**ZONING AMENDMENT,
PLANNED UNIT DEVELOPMENT &
SUBDIVISION STAFF REPORT**

Date: September 17, 2015

<u>NAME</u>	Zimmer Development Company
<u>SUBDIVISION NAME</u>	Campus Crest Subdivision
<u>LOCATION</u>	139 East Drive (East side of East Drive extending to the West side of Long Road (not open), 90'± North of Windham Court)
<u>CITY COUNCIL DISTRICT</u>	District 6
<u>PRESENT ZONING</u>	R-3, Multiple-Family Residential District
<u>PROPOSED ZONING</u>	R-3, Multiple-Family Residential District
<u>REASON FOR REZONING</u>	To remove conditions of previous zoning approvals.
<u>AREA OF PROPERTY</u>	1 Lot / 10.6 ± Acres
<u>CONTEMPLATED USE</u>	Subdivision approval to create 1 lot, Planned Unit Development approval to allow multiple buildings on a single building site, and Rezoning from R-3, Multiple-Family Residential to R-3, Multiple-Family Residential, to remove conditions of previous zoning approvals, to allow an apartment complex. It should be noted, however, that any use permitted in the proposed district would be allowed at this location if the zoning is changed. Furthermore, the Planning Commission may consider zoning classifications other than that sought by the applicant for this pr

EXISTING SITE PLAN

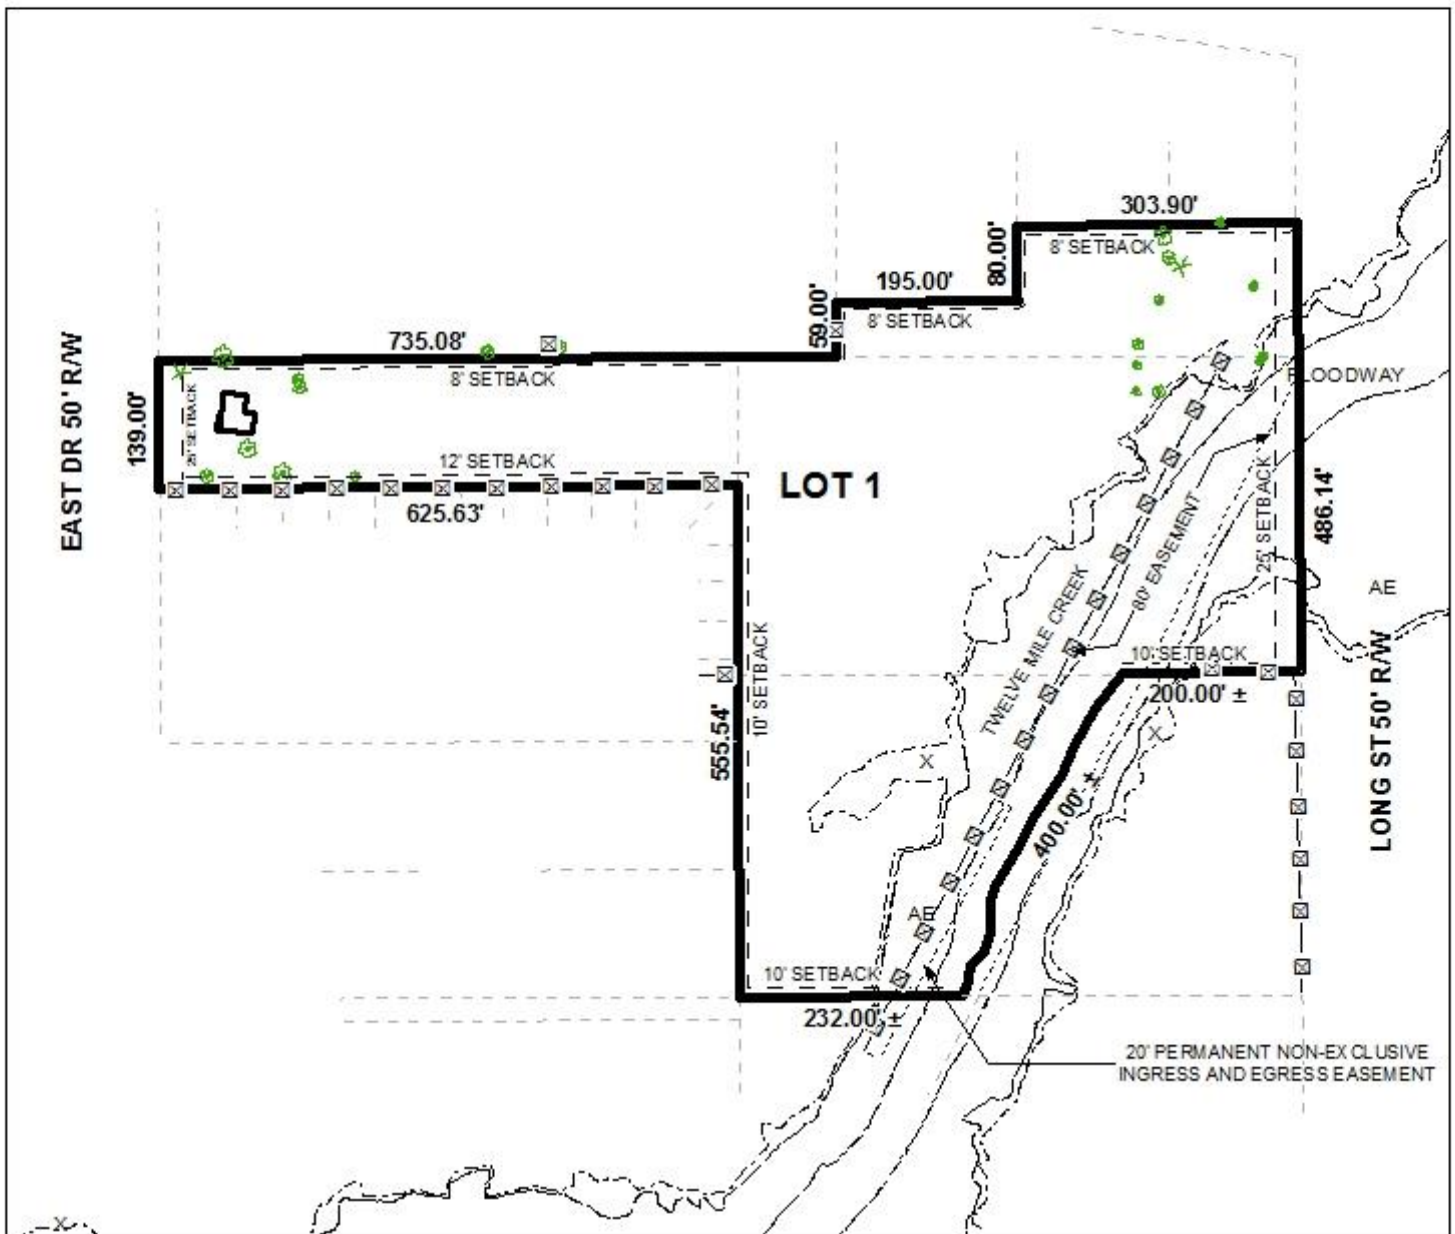
- 1. Label the Minimum Finished Floor Elevation (MFFE) for each lot.

The 25-foot minimum building setback is not shown on the preliminary plat along Long Street, but it is depicted for East Drive. The setback is shown for both streets on the PUD site plan. The plat should be revised to show the minimum building setback along all abutting rights-of-way.

- 1) Revision of the plat to depict a 25-foot setback along all abutting street frontages.

PROPOSED SITE PLAN

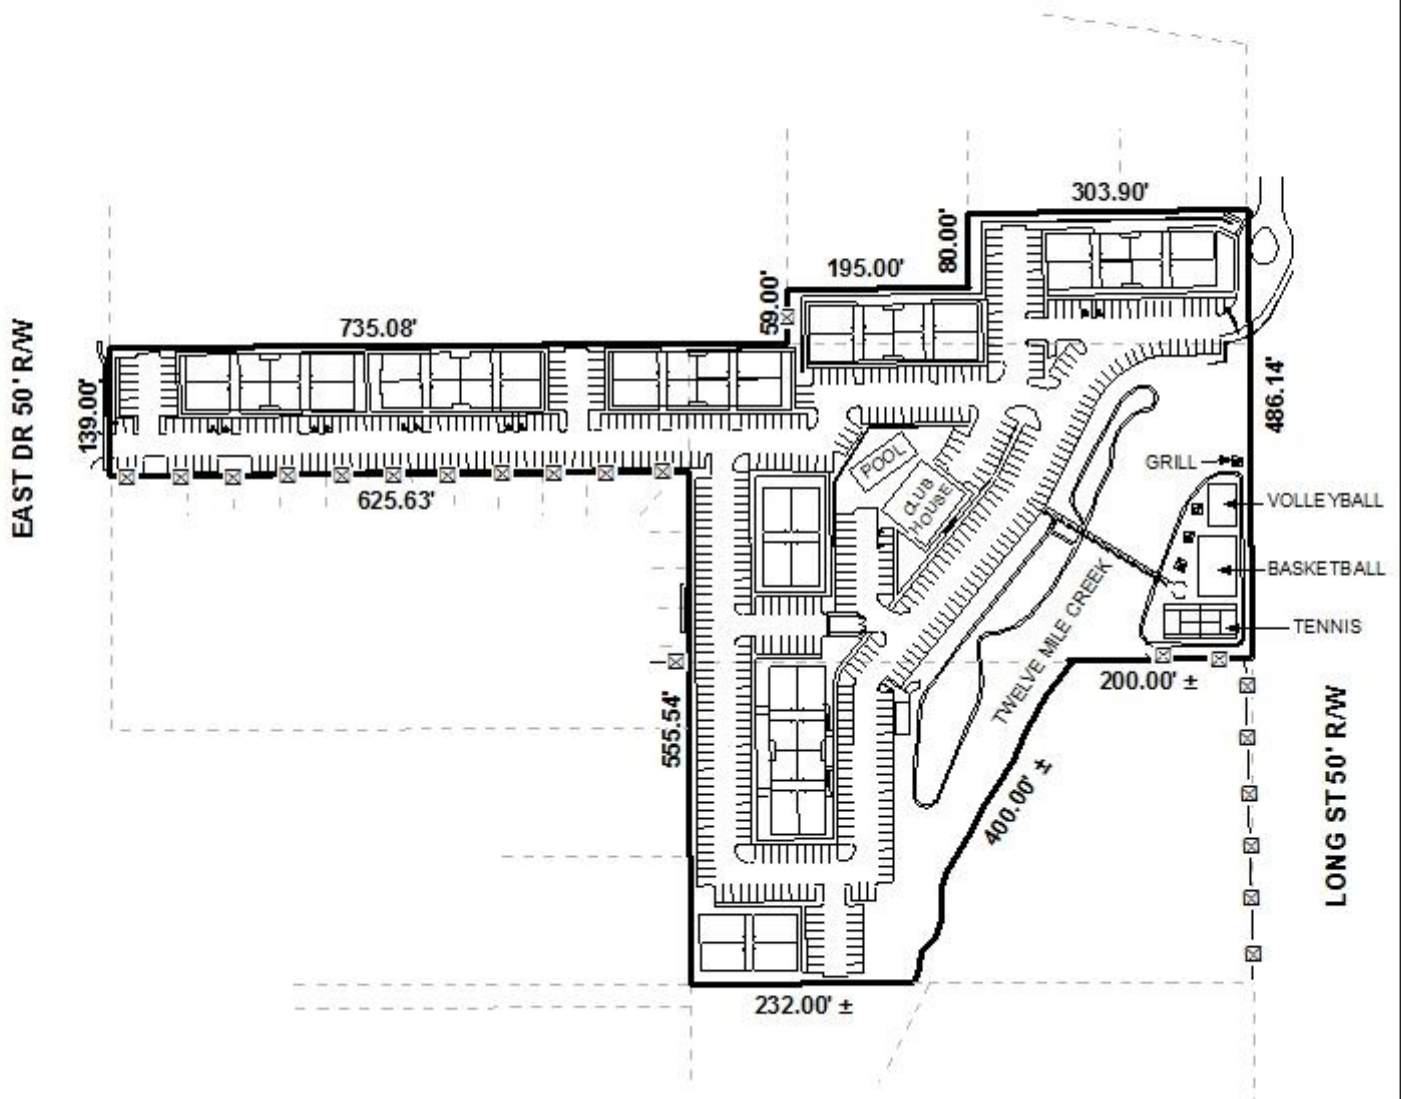
The applicant proposes to develop a 168 unit, 516 bed apartment complex with 567 parking spaces. The apartments will be in 8 three-story buildings, and there will be a separate club house with pool, a maintenance building, and tennis, volleyball and basketball courts. The recreational courts will be located via pedestrian bridge on the East side of Twelve Mile Creek. Vehicular, gated access for residents and guests will be from Long Street, while an “*emergency vehicle only*” gated access point will be provided on East Drive.

The site plan includes information regarding landscape area compliance, however, no information is provided regarding tree compliance. The site will meet landscape area requirements. A site plan also depicting full compliance with the tree requirements of the Zoning Ordinance will be required at time of submittal for land disturbance permits.

The site is located within the area impacted by the amended multi-family parking requirements adopted by the City Council earlier in 2015. The amendment requires “One (1) space per bedroom plus 10% of the total amount of spaces” for the development, which staff calculates to be $516 \times 1.1 = 567.6$ or 568 parking spaces required. It appears that the site is 1 parking space short of the total required.

One dumpster is depicted on the site plan. The dumpster and enclosure must comply with Section 64-4.D.9. of the Zoning Ordinance.

The site abuts single-family residences. A minimum 6-foot high wooden privacy fence should be provided where the site abuts single-family residences. The fence should be no taller than 3-feet where it is within the 25-foot setback from the improved portions of Long Street or East Drive.

It is assumed that the primary residents of the proposed complex will be students attending the nearby University of South Alabama. For this reason, it is recommended that a pedestrian gate be provided at both the Long Street and the East Drive frontages. A sidewalk is depicted as being provided along East Drive, and such should also be depicted and provided for the frontage on the improved portion of Long Street.

- 1) Submission of two copies of a Traffic Impact Study;
- 2) Revision of the site plan to depict 568 parking spaces;
- 3) Revision of the site plan to depict and label an “emergency vehicle only” access gate on East Drive, and a pedestrian gate;
- 4) Revision of the site plan to depict a 6-foot high wooden privacy fence (3-feet high in the 25-foot setback) where the site abuts single-family residences;
- 5) Revision of the site plan to depict and label any other perimeter fencing, and a pedestrian gate at the Long Street entrance; and
- 6) Revision of the site plan to depict a sidewalk on the to-be improved segment of Long Street.
